# Minto Logistics Hub Modification 1

Layout and Staging Changes  
State Significant Development Modification Assessment  
(SSD-7500-Mod-1)

December 2021

Published by the NSW Department of Planning, Industry and Environment

Figure 4 | Proposed Layout and Staging

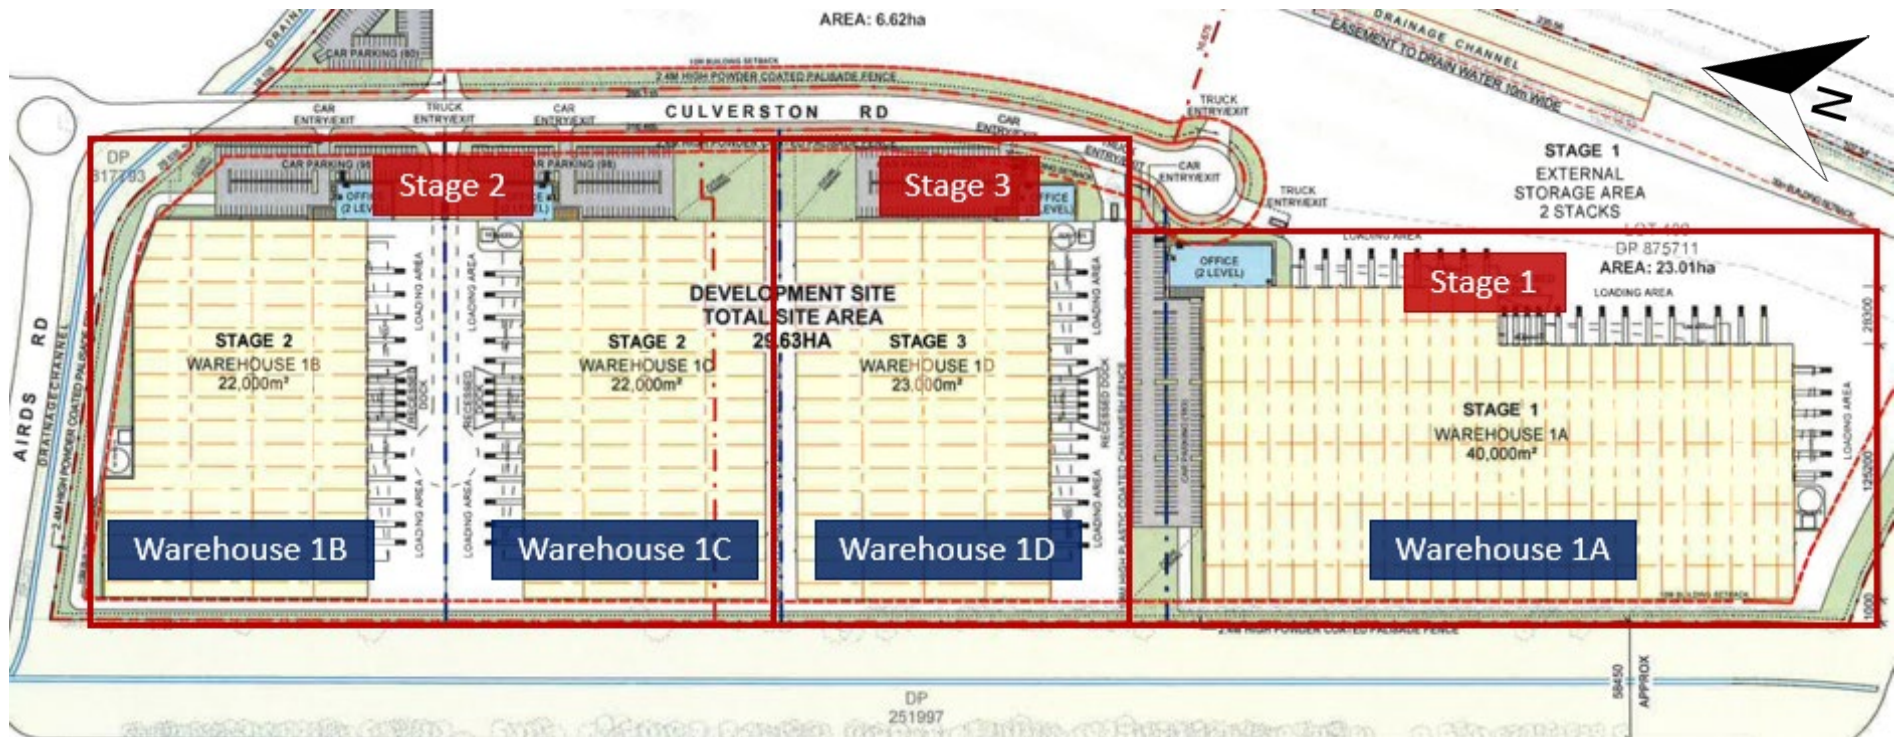
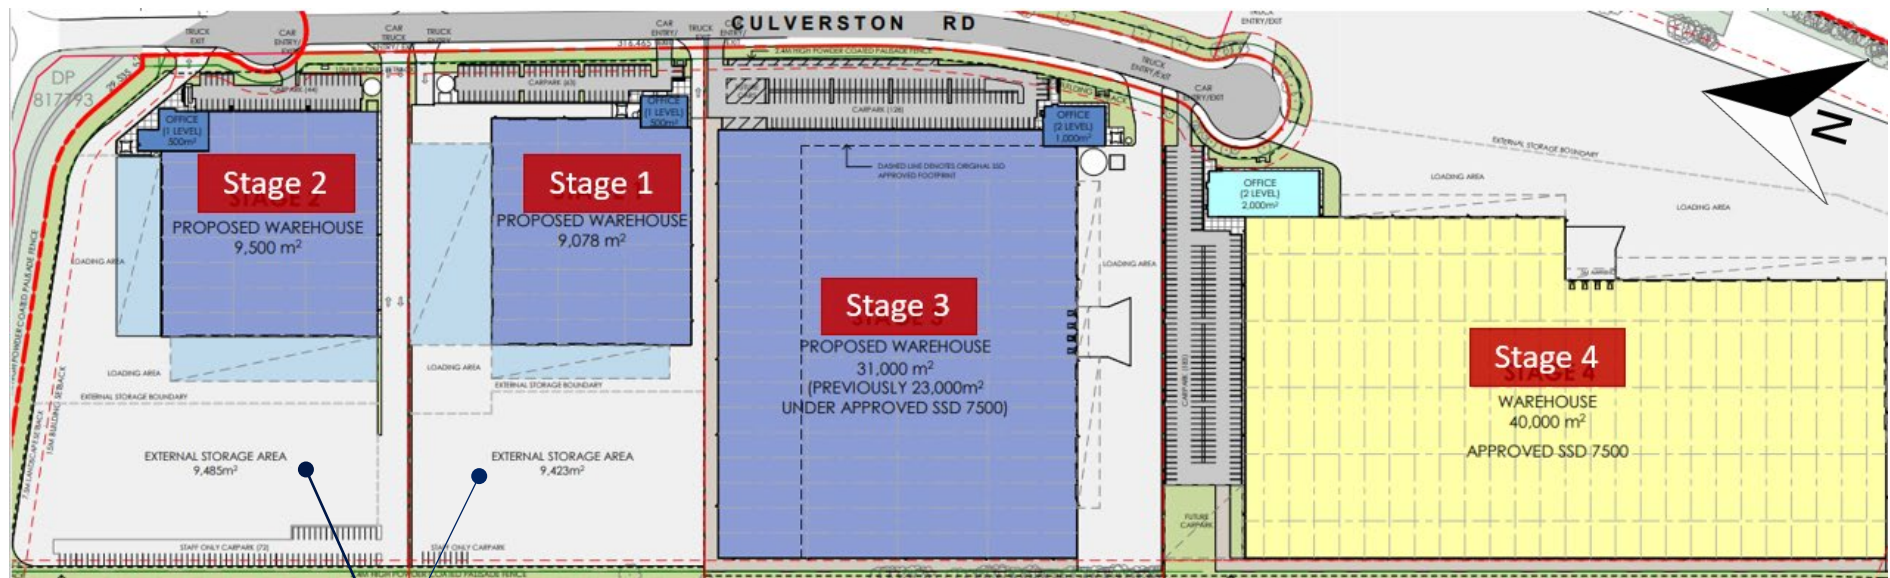
**Council** recommended that consideration be given to the proposed access to the Stage 2 warehouse, as the driveways appear to be within close proximity to the existing Culverston Road and Airds Road intersection. Council also requested that consideration be given to the screening and visibility of the new external storage areas and the height of any structure.

Council reviewed the proposed modification and requested consideration be given to the visibility of the new external storage areas and recommended a limit be placed on its height.

- Council reviewed the proposal and did not raise any objections, however, noted the Department should give consideration to the proximity of the Stage 2 warehouse's driveway to the Culverston Road / Airds Road intersection to the north.

On 3 December 2021, the Applicant responded to the issues raised by Council. The Applicant advised the new driveway locations are designed in accordance with Australian Standards and located a significant distance (over 60 m) from the Culverston Road / Airds Road intersection, achieving sight distance requirements. The Applicant also noted its swept path analysis submitted as part of the application demonstrated vehicles up to a 26 m B-Double could safely use the subject driveway.

The Department recommends Condition A6 be modified to ensure heights in the external storage areas of Stages 1 and 2 are in line with what was assessed in the VIA, limiting Stage 1 to 7.5 m in height and Stage 2 to two containers high.

- The Department notes the exit driveway for the Stage 2 warehouse is located approximately 60 m away from the intersection of Culverston Road / Airds Road and existing conditions of consent require all access points to be designed to Australian Standards and Austroads requirements. Further, Culverston Road is a cul-de-sac which will be used primarily by

**Figure 8 |** View of Stage 1 and 2 Warehouse, as approved from Airds Road

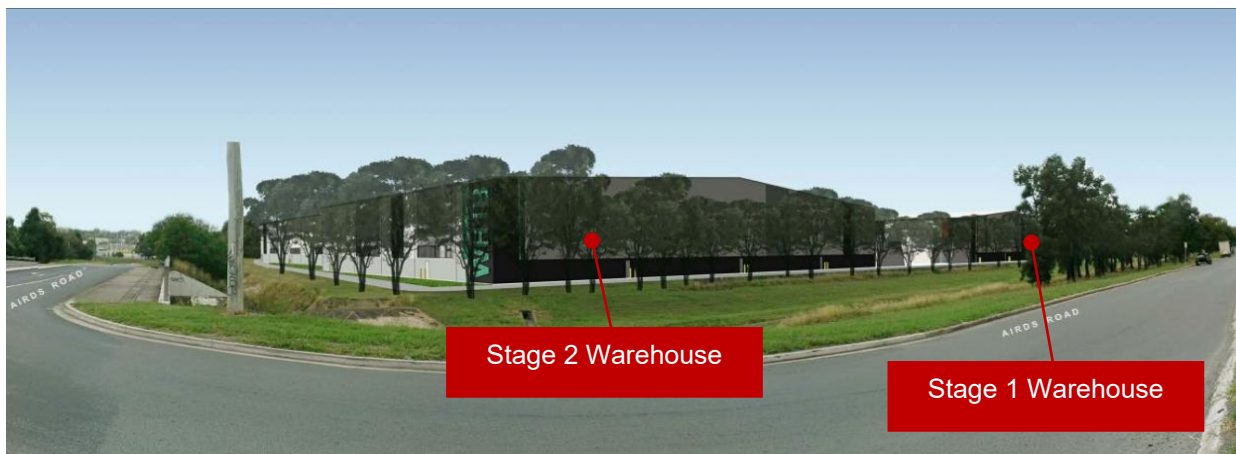
To assess this potential impact, the Applicant supplied a Visual Impact Assessment (VIA) as part of its Modification Report. The VIA assessed the impact the new external storage areas would have from key vantage points, including from Airds Road (see **Figure 7**). For comparison, a similar view of the approved development is seen in **Figure 8**.

The VIA found that although the proposal would introduce new external storage areas on the north western side of the site, these would be in place of existing built form (approved as 13.7 m in height), at a lesser height and bulk and adequately screened by significant existing and proposed vegetation. As such, the VIA concluded that the visible impacts of the development would be negligible and comparable to the approved development.

The Department has reviewed the proposed visual changes and the Applicant's VIA and notes the visual changes will be most notable along Airds Road (to the north and west of the site), with significant reductions in built form in Stages 1 and 2. A review of the proposed and approved photomontages from Airds Road (**Figure 7** and **Figure 8**) demonstrates the reduction in warehouse size has significantly reduced the building bulk, reducing the visual prominence of the development.

The Stage 1 external storage area proposes a height higher than what was consented to in the approved external storage area. However, Stage 1 external storage area is in the middle of the site, screened from the public realm to the north, south and east by Stages 2, 3 and the Stage 1 warehouse, respectively. To the west, the warehouse is setback from Airds Road by a 75 m wide drainage canal and screened by a significant 5 m landscape buffer and a 2.4 m high fence, reducing the dominance of the greater external storage height. The Department also notes the 7.5 m height is significantly less than the approved height of the warehouse structure (13.7 m).

The Department considers the significant roadway setbacks, large buffers of planned and existing vegetation and the approved fence will adequately screen the external storage area from the public realm. This combined with the significant reduction in bulk and height in proximity to the northern and western boundaries from the reduction in warehouse sizes, will ensure that the visual impacts associated with the modified development are in line with those considered in the original assessment.
